**Re: Florida Power & Light Company
West County Energy Center Unit 3 Project
DEP File No. 0990646-002-AC (PSD-FL-396)**

West County Energy Center Unit 3 PSD Draft Air Permit, issued April 25, 2008 Florida Power & Light Company – Comments

West County Energy Center Unit 3 Technical Evaluation and Preliminary Determination, issued April 25, 2008 Florida Power & Light Company – Comments

West County Energy Center Unit 3 Section IV. Appendices, issued April 25, 2008 Florida Power & Light Company – Comments

FIGURE 1.1.0-1

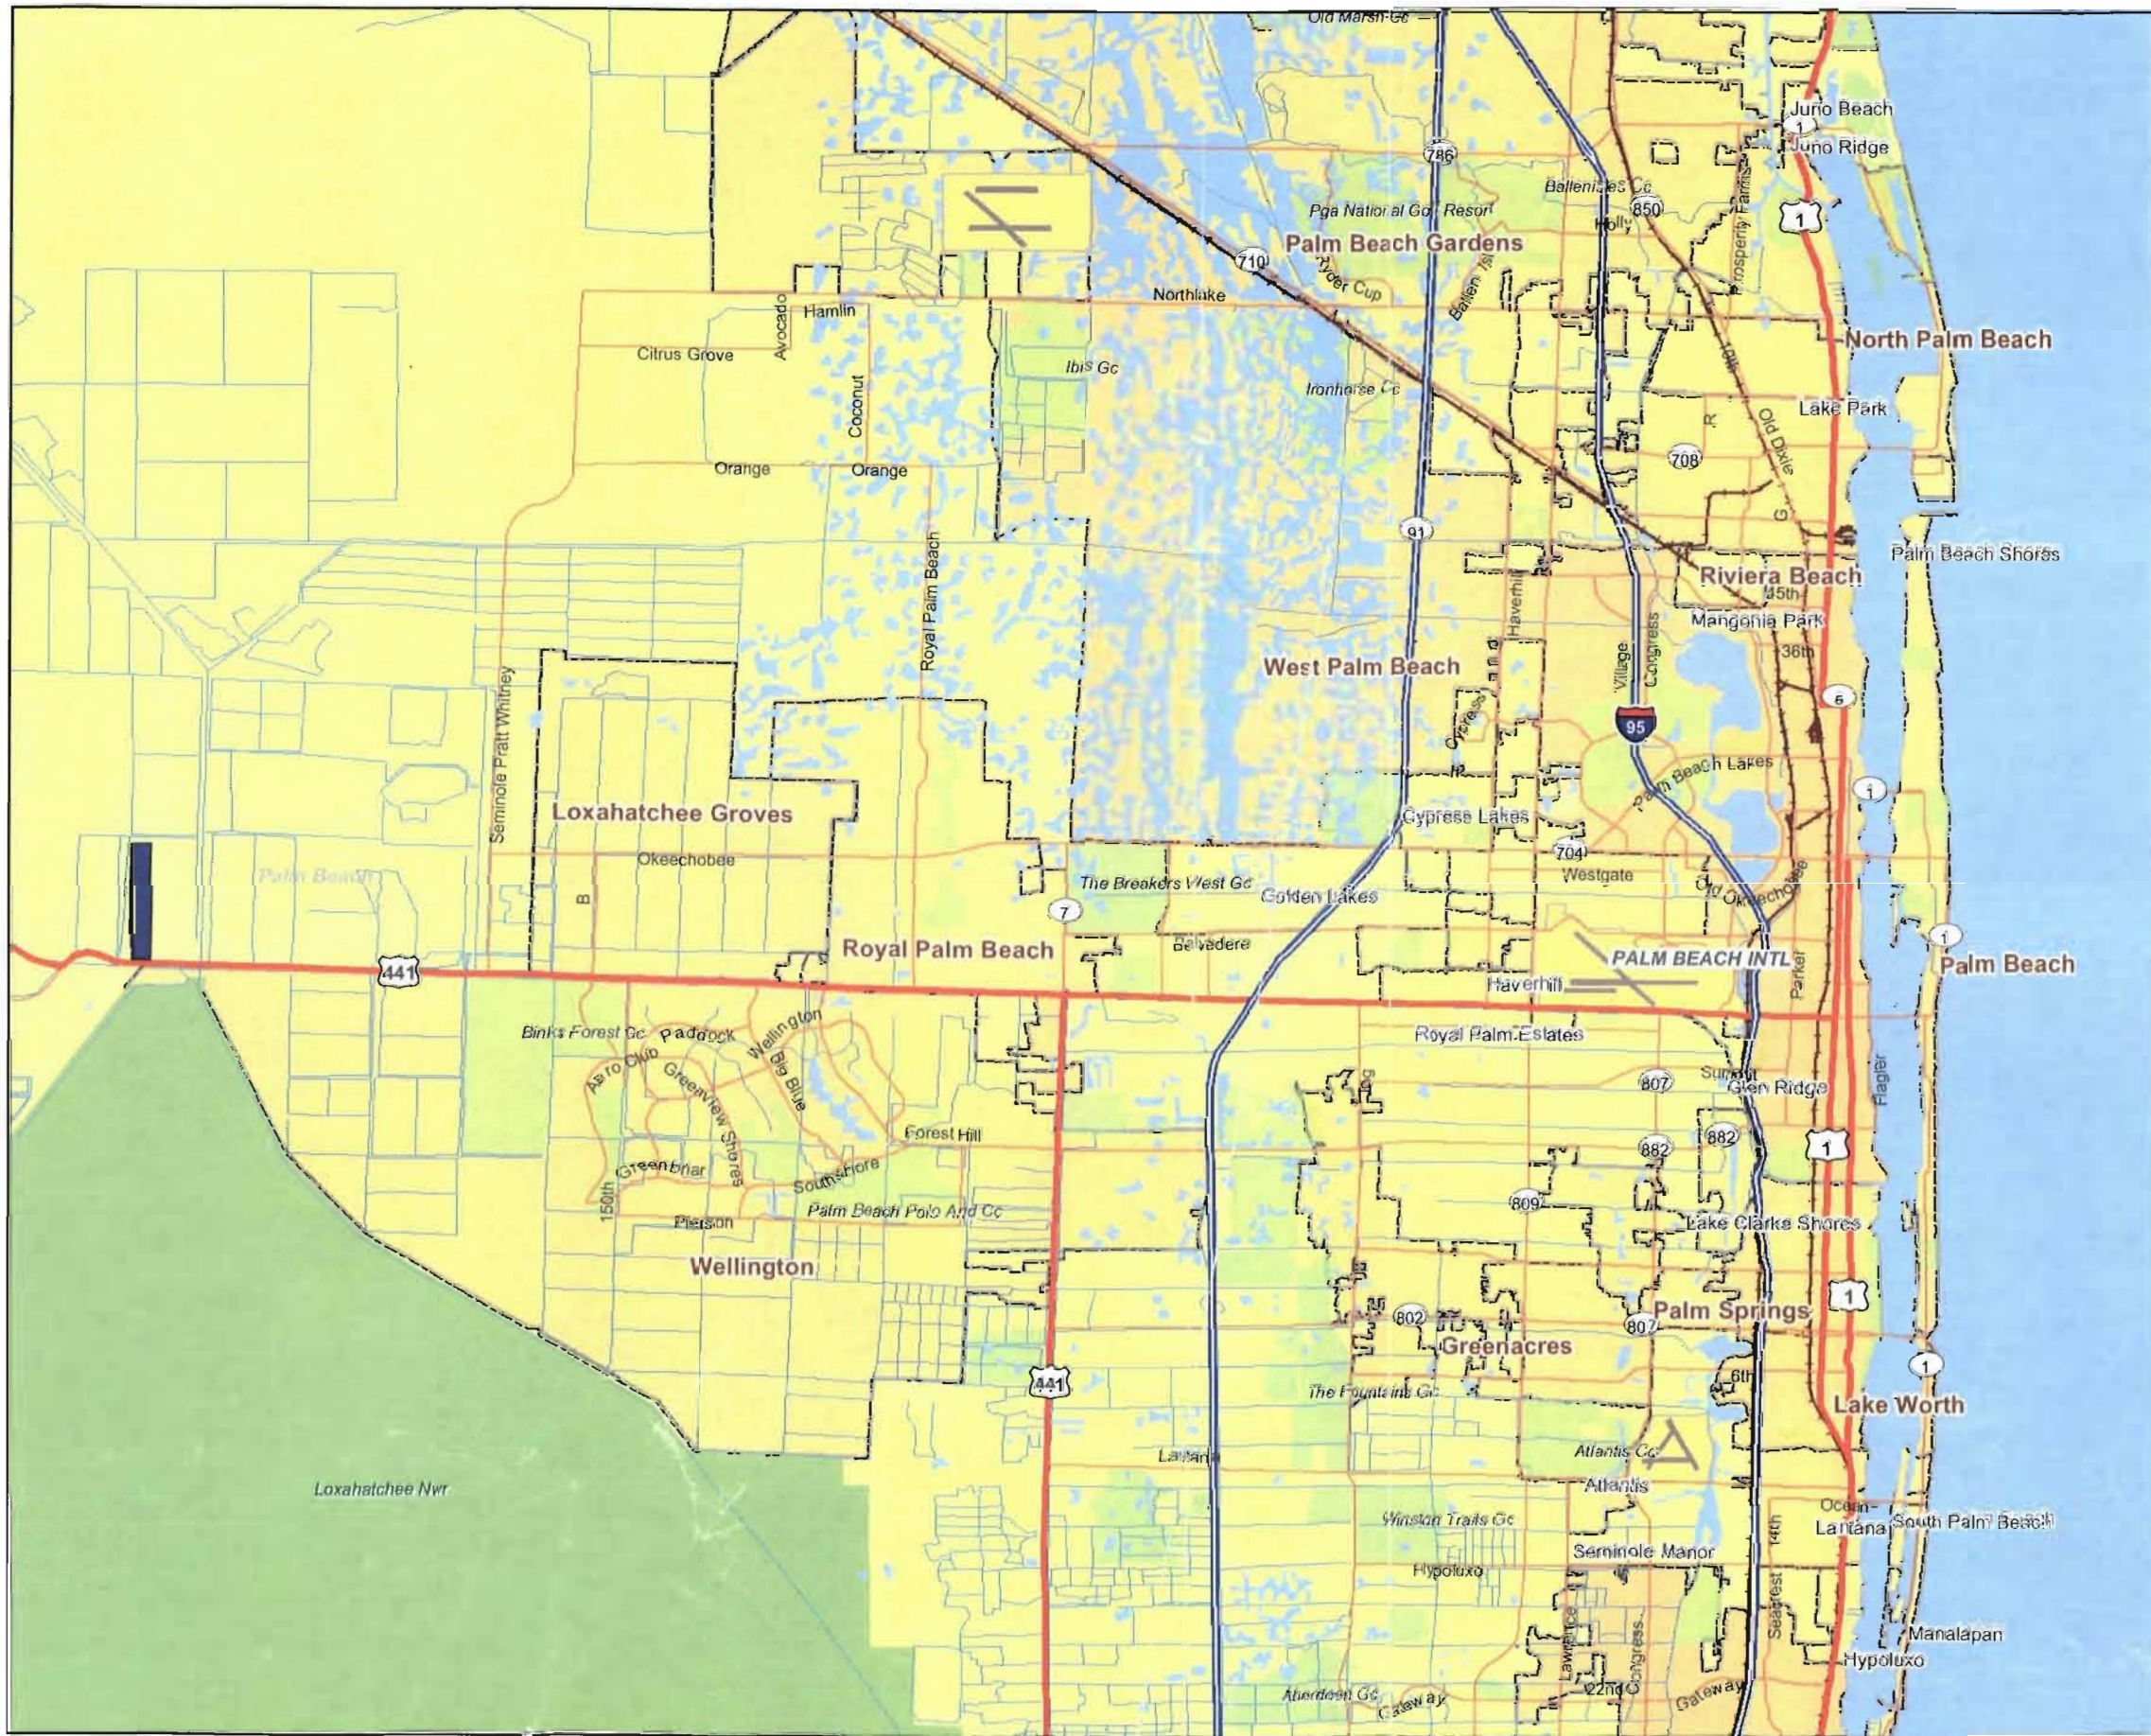
1. **Page 2, Figure 1:** SW St. Lucie should be removed from this Figure, as it is no longer a proposed FPL project.
2. **Page 2, Facility Description and Location:** For accuracy and consistency with the Site Certification Application (SCA), please make the corrections indicated below. In addition, attached please find an updated project location map (Figure 1.1.0-1 from the SCA) which could be used to replace Figure 3 in the Draft Technical Evaluation and Preliminary Determination.

“With respect to Figure 3 below, the ~~Town of Loxahatchee Groves is located approximately 4 miles east of the site. The Villages of Wellington Village of Wellington is the closest municipality to the Site and is located south of the Site and State Road 80. Loxahatchee Groves, the second closest municipality to the Site, is located approximately 4.5 miles east of the Site. and Royal Palm Beach are~~ is also located several miles generally east of the site. Other areas such as The Acreage, Deer Run and ~~Indian~~ Fox Trails are populated and unincorporated communities east of and near to the site. ~~The closest residence is in the Deer Run subdivision and is approximately 0.7 miles northeast of the northeast corner of the Site.~~”
